**Subject: Safety Recall 04V-327
(Ford Number 04S15)**

SUBJECT: Safety Recall 04S15:
Certain 2003 Model Year F-Super Duty and Excursion Vehicles Equipped With 6.0L
Diesel Engine
Negative Battery Terminal to Engine Block Connection

**CERTAIN 2003 F-SUPER DUTY AND EXCURSION VEHICLES EQUIPPED
WITH 6.0L DIESEL ENGINE —
BATTERY GROUND CABLE INSPECTION**

FIGURE 1

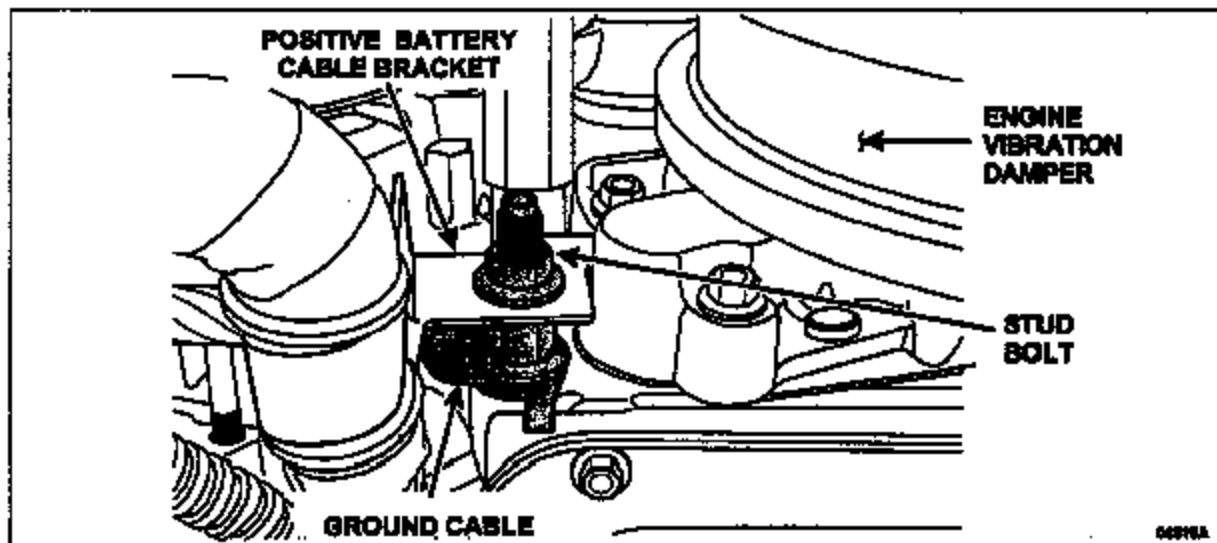
In some of the affected vehicles, it may be possible that the ground stud that retains the negative battery terminal eyelet to the engine block may be loose. A loose battery ground wire may produce high resistance to current flow. As a result, current may take an alternate path to ground through the radio suppression strap causing it to heat and potentially melt or ignite adjacent components.

1. Raise and support the vehicle on a hoist.
2. Locate the battery ground cable stud bolt at the right front corner of the engine block. See Figure 1. Grasp the ground cable assembly by hand and determine if it is loose at the block.

3. Remove the positive battery cable bracket from the stud bolt.
4. Remove the ground cable stud bolt from the engine block and discard.
5. Inspect for evidence of arcing or carbon buildup on the ground cable eyelet terminal. Clean as necessary.
6. To ensure a good ground path, use a wire brush or equivalent to clean the engine block surface and ground cable mating surfaces.
7. Install the new ground stud bolt. Tighten it to 62.5 Nm (46 lb-ft).
8. Install the positive battery cable bracket to the stud bolt. Tighten it to 30 Nm (22 lb-ft).
9. Grasp the ground cable assembly by hand and make sure it is tight at the engine connection.
10. Lower the hoist.
